ADDENDUM NUMBER 2

BID # 16-32 Blue Colt Book Store Renovation

**ADDENDUM NO. 2**

**MIDDLESEX COUNTY COLLEGE BID # 16-32**  
**BLUE COLT BOOKSTORE RENOVATION AND NEW CAFE**

FSI

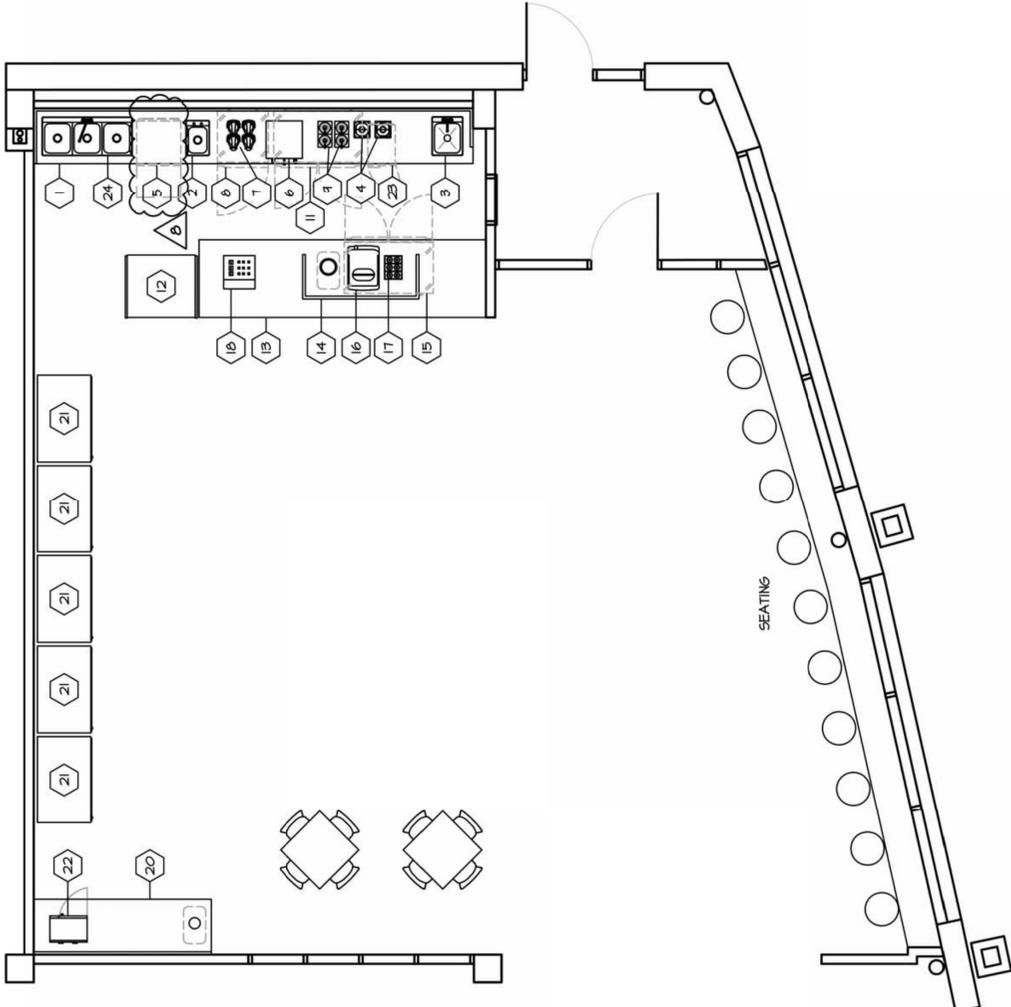
**Dwg. FS1:** Item Number (5) – The “Undercounter Ice Bin” is to be deleted from the project and replaced with an “Undercounter Dish Washer”, basis of design is “Hobart LXEH-2”.

**Undercounter Dish Washer Specification:**

LXe Dishwasher, undercounter, 23-15/16"W x 23-9/16"D x 32-1/2"H, high temperature sanitizing, (32) racks/hr, fresh water rinse, .74 gal/rack, delime notification, auto chemical priming, service diagnostics, detergent & rinse aid pump, 120/208-240(3W)/60/1-ph, 30.5 amps, cULus, NSF, ENERGY STAR®  
Provide a 2” drain line, a ¾” water line, and appropriate power supply.
